HISTORIC LANDMARK COMMISSION
JULY 22, 2019
PERMIT IN NATIONAL REGISTER HISTORIC DISTRICT
NRD-2019-0023
2105 NEWFIELD LANE
OLD WEST AUSTIN HISTORIC DISTRICT

Demolish a 1940 contributing house and replace with new construction.

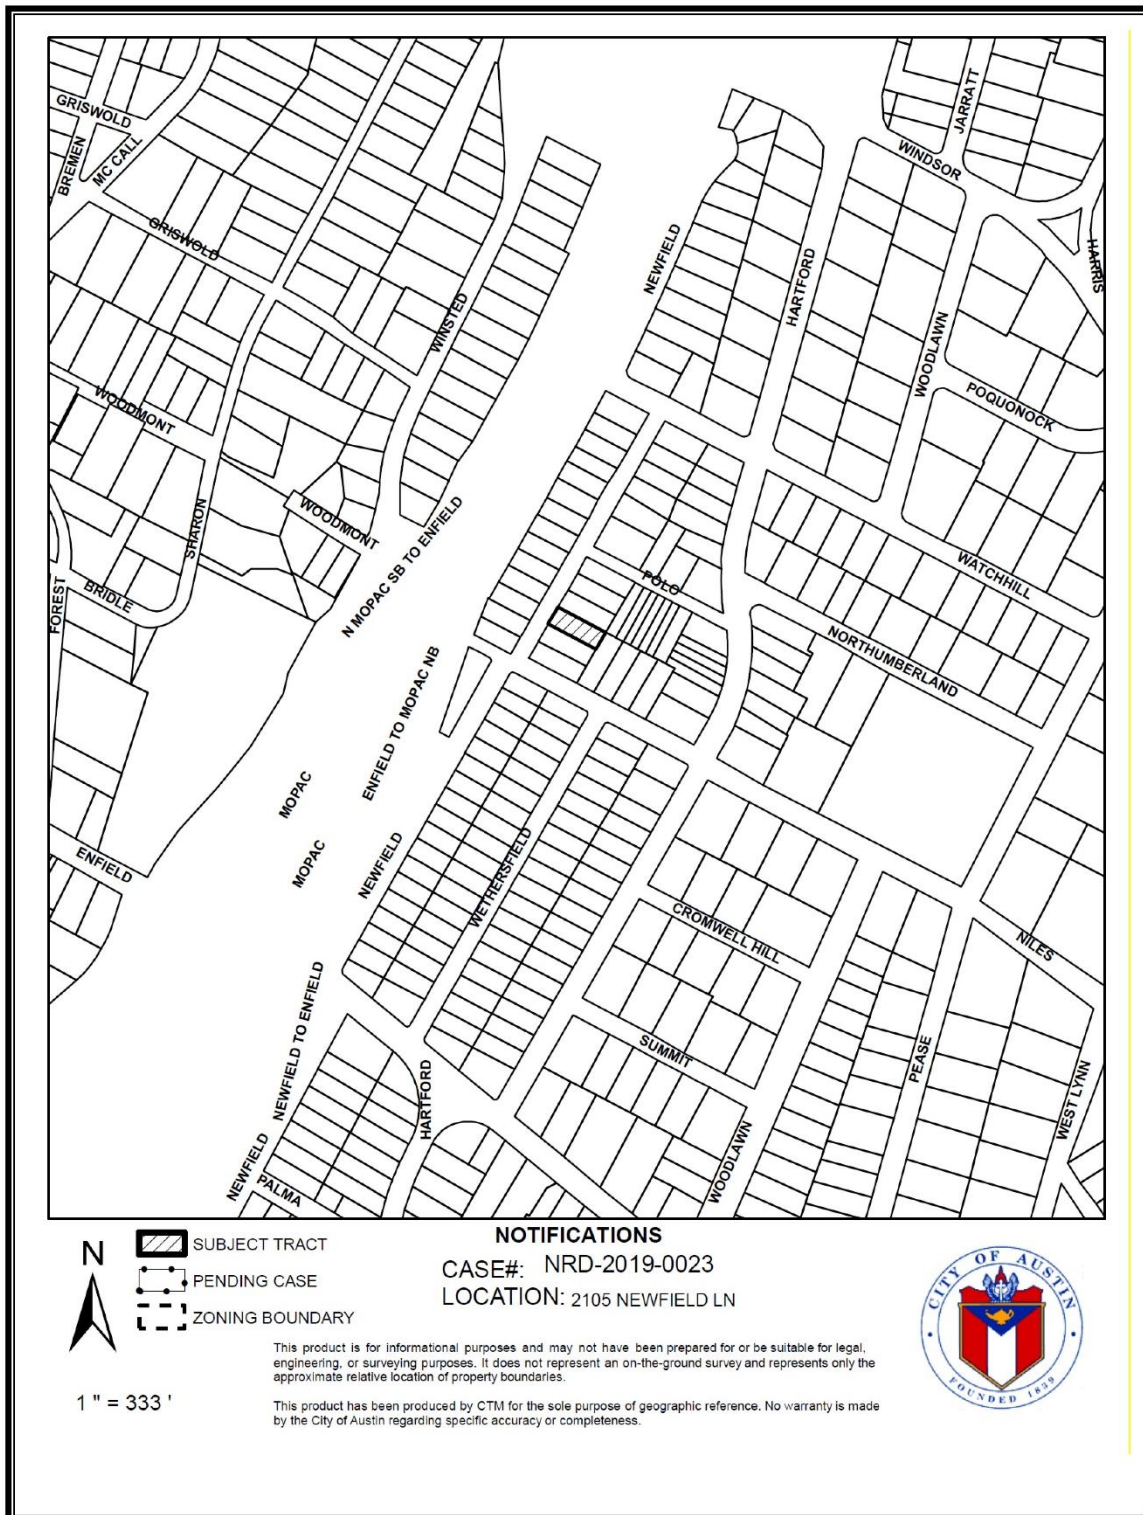
The proposed new construction will require demolition of a contributing structure. It is differentiated from historic properties in the district by its modern cladding, fenestration, and two-story form. The proposed front-yard placement of the auxiliary garage structure and deep setback of the main house are not compatible with the lot placement of historic-age structures on the streetscape, nor are the proposed architectural features (metal siding, compound roof form, and irregular fenestration) compatible with the historic structures in the district.

Consider retention and adaptive reuse of the existing house. For the proposed new construction, move the detached garage to the rear of the main house. Consider adding a porch to create a smooth transition between the two-story structure and the streetscape.

Encourage rehabilitation and adaptive re-use of the existing building, including consideration of a demolition delay, as the primary building is contributing to the historic district. If the demolition permit is released, require completion of a City of Austin documentation package, consisting of photographs of all elevations, a dimensioned sketch plan, and a narrative history, for archiving at the Austin History Center. Comment on and release plans for new construction.
